Inspection Photos

Operator: ST CROIX OPERATING INC # 81490

Location ID: 458423

Inspection Doc. Number: 682504291

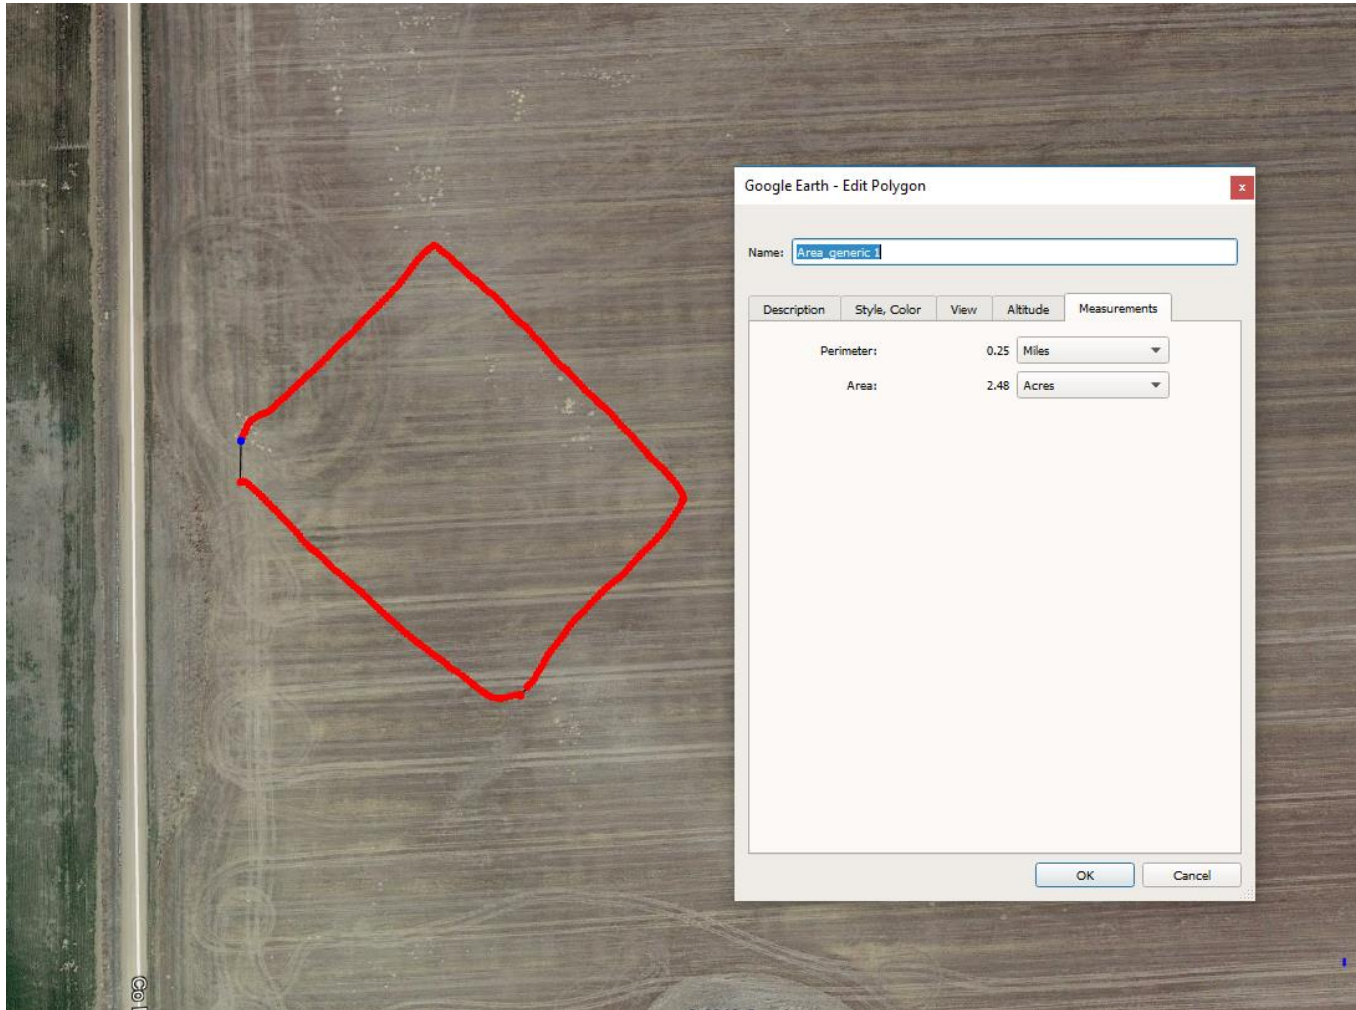
Photo 1: Aerial image of construction location. A disturbance area of 2.48 acres was mapped on 12/19/2018 using a Trimble Juno 3B handheld device; this appears to exceed the permitted 2A disturbance area of 2 acres.
